UNITED STATES
ATOMIC ENERGY COMMISSION
WASHINGTON, D.C. 20545

Change No. 22
License No. DPR-6

CHANGE NO. 22 TO TECHNICAL SPECIFICATIONS

FACILITY LICENSE NO. DPR-6

Figure 5.5 - (Issued with Change No. 12 dated February 9, 1971.)
BIG ROCK POINT F FUEL
 WITH INSTRUMENTED FUEL ROD

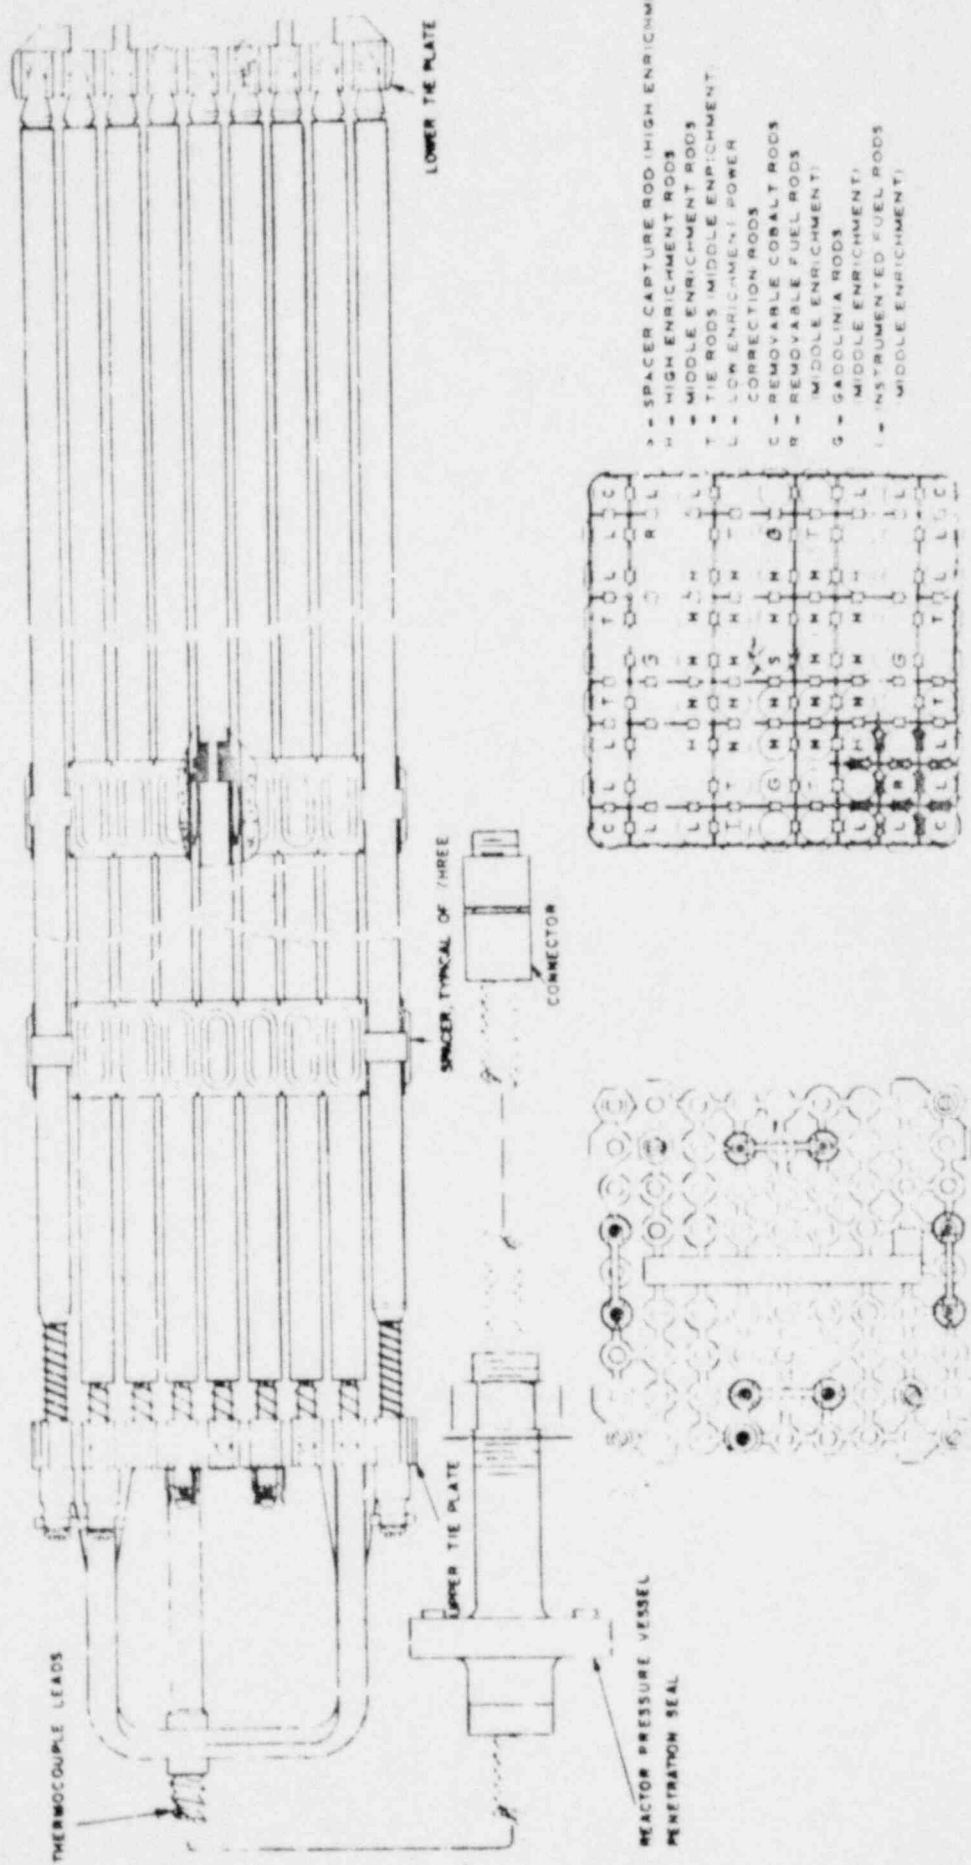
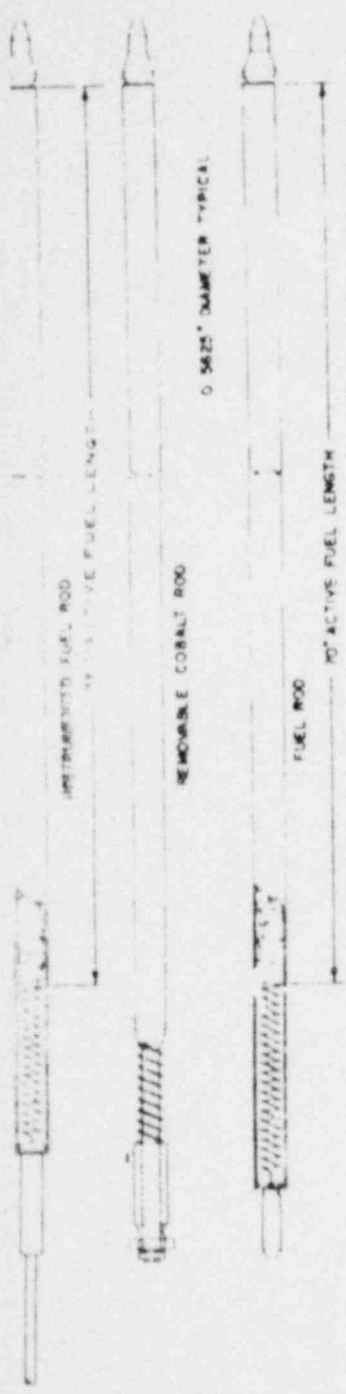
"The general dimensions and configuration of the developmental fuel designs shall be as shown in Figures 8.1 through 8.5. The principal design features shall be substantially those shown in Table 8.1."
2. In Section 8.1, add Figure 8.5, Big Rock Point F Fuel with Instrumented Fuel Rod.
3. Add a new Section 8.1.3 to read:
